Technical Basis Document No. 4: Mechanical Degradation and Seismic Effects

POTENTIAL FOR THERMALLY INDUCED ROCKFALL BASED ON DOE ANALYSIS

The DOE assessment of the potential for thermally induced rockfall is summarized on p. 5-7 of TBD #4 where it is stated that combined in situ and thermally induced stresses would not cause any significant ground collapse in the emplacement drifts. The basis for this conclusion is summarized in figures 5-5 and 5-6 (p. 5-9-5-10) of TBD #4. Lines were inserted into the two figures by CNWRA staff (p. 54 and 55 of this notebook) to represent the lower-bound rock strength provided by DOE. The lower-bound rock strength was taken from figure 4-11 (p 4-21) of TBD #4. DOE based its conclusion on comparing its calculated stresses with the estimated mean rock strength.

Figure 5-5. Elastic Principal Stress Path Histories for Points at Increasing Depth from Emplacement Drift Crown (a) and Springline (b) for Lithophysal Rock, Modulus from Lowest Quality Category 1

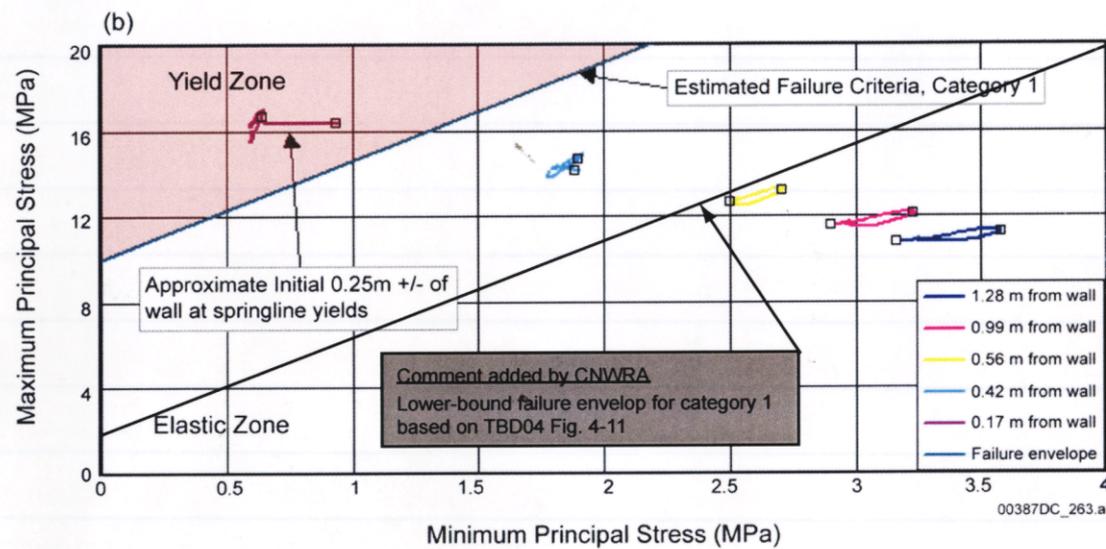
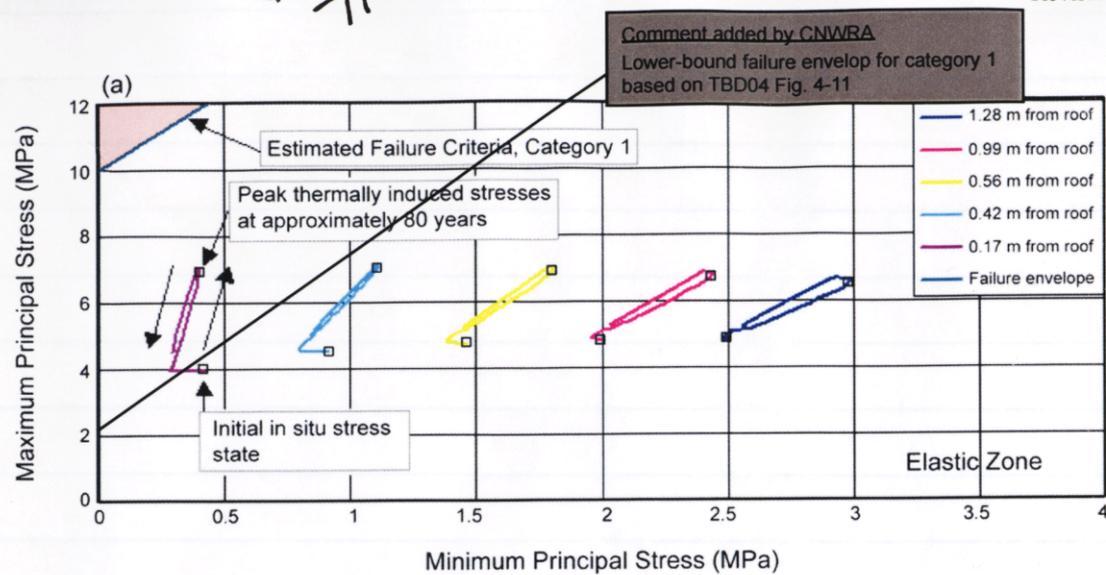
The DOE conclusion, however, would have been different if the full range of rock strength between the upper and lower bound were considered in the interpretation of the calculated stresses. The following observations arise from comparing the lower-bound strength with the calculated stresses.

For the lowest-grade rock (category 1)

- Stresses near the drift surface in the roof area would attain potentially unstable conditions if the rock strength is close to the estimated lower bound.
- Stresses near the drift surface in the sidewall area indicate potentially unstable conditions for values of rock strength close to or smaller than the estimated mean strength.
- The DOE plot does not include the time dimension that would have indicated the persistence of the potentially unstable stress conditions. Sidewall instability, if persistent, would ultimately cause the roof areas to be unstable. Such progression of instability would result in bell-shaped failure zones.

Figure 5-6. Elastic Principal Stress Path Histories for Points at Increasing Depth from Emplacement Drift Crown (a) and Springline (b) for Lithophysal Rock, Modulus from Highest Quality Category 5

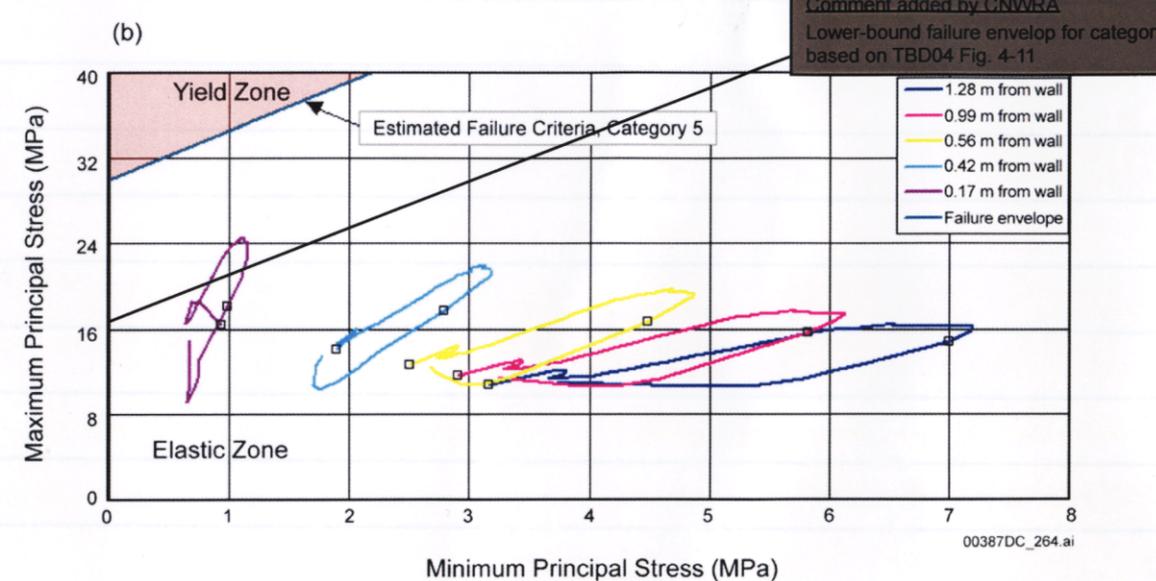
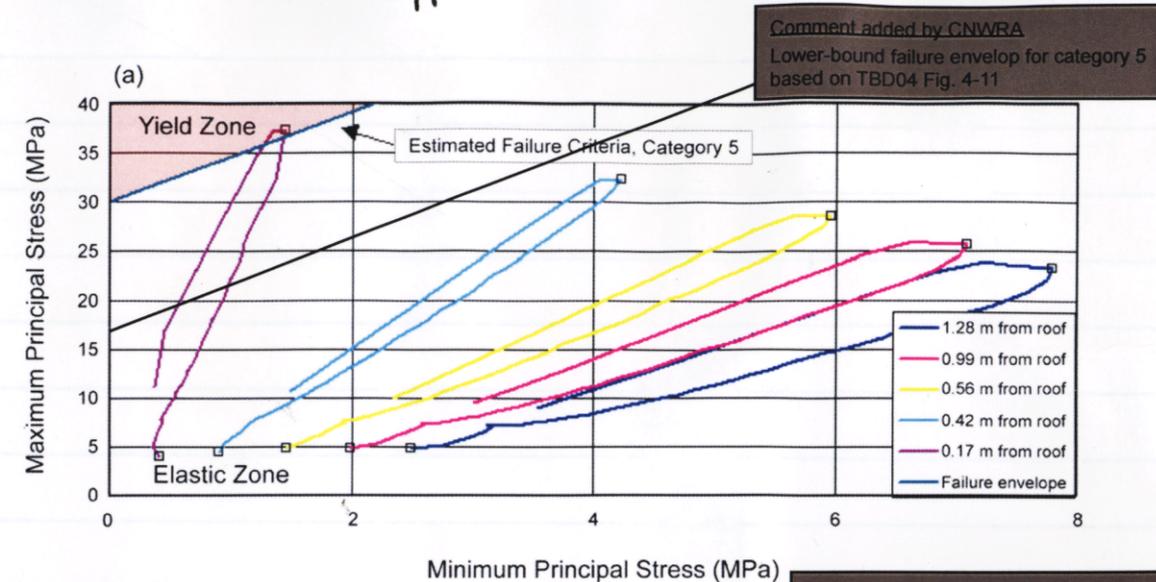
For the highest-grade rock (category 5)

- Stresses near the drift surface in the roof area would attain potentially unstable conditions if the rock strength is close to or smaller than the estimated mean strength.
- Stresses near the drift surface in the sidewall area indicate potentially unstable conditions for values of rock strength close to the estimated lower-bound strength.
- The DOE plot does not include the time dimension that would have indicated the persistence of the potentially unstable stress conditions. Occurrence of instability in the roof areas with the sidewall remaining stable would result in chimney-shaped failure zones.
